Request of Class II Permissive Change

Company name: Seeed Technology Co., Ltd

FCC ID: Z4T-WM1303-A

The major change filed under application is:

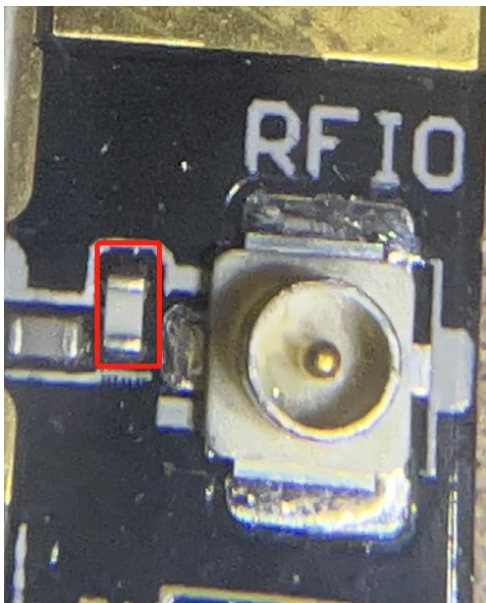
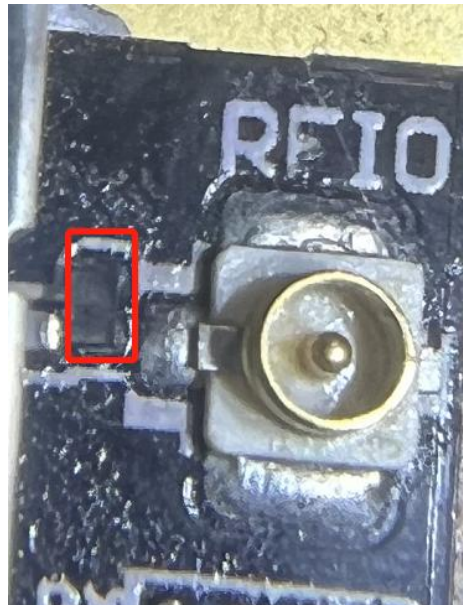
(1) Add ESD protection diode substitute of Antenna

Original

New

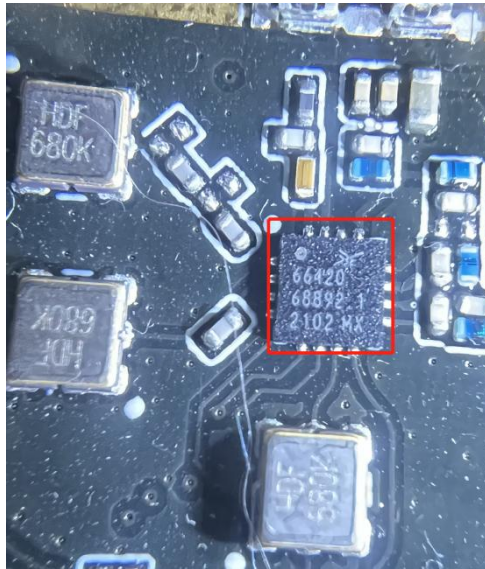
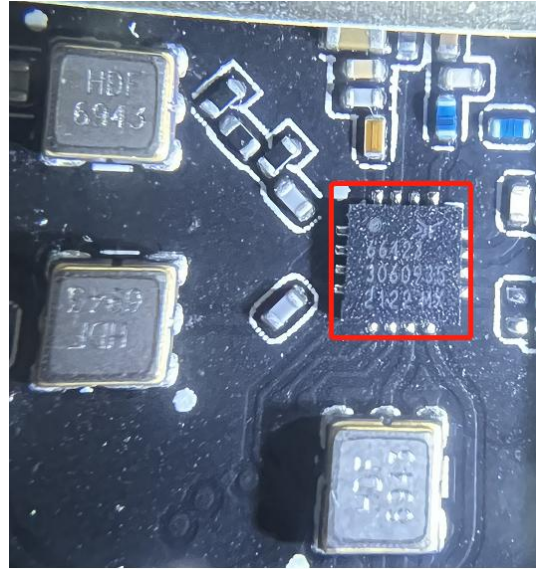
(2) Add the PA substitute material

Original

New

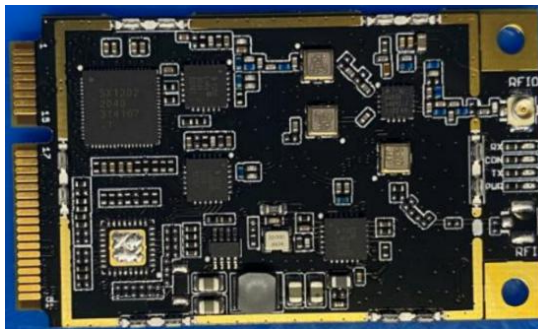
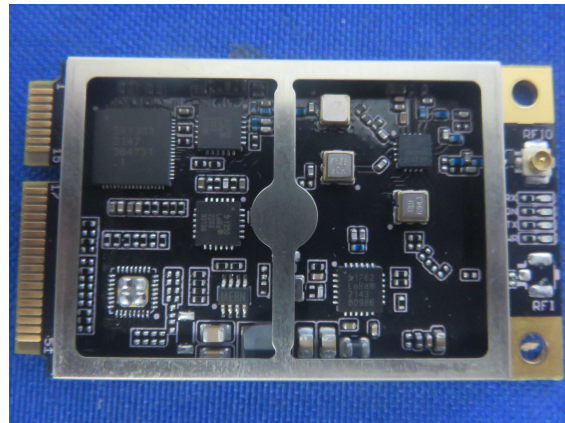
(3) Changing a few parts of Layout

Original

New

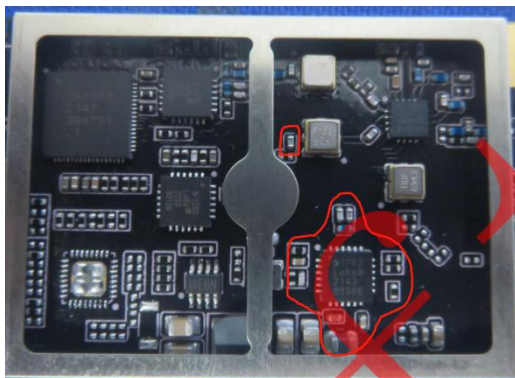
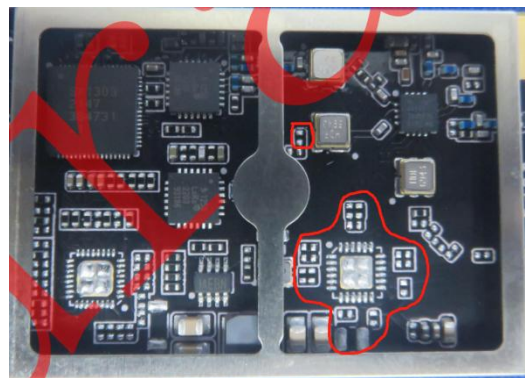
(5) Add a model which deleting components related to SX1262 on BOM which have not activated on function;
as follows:

Original

New
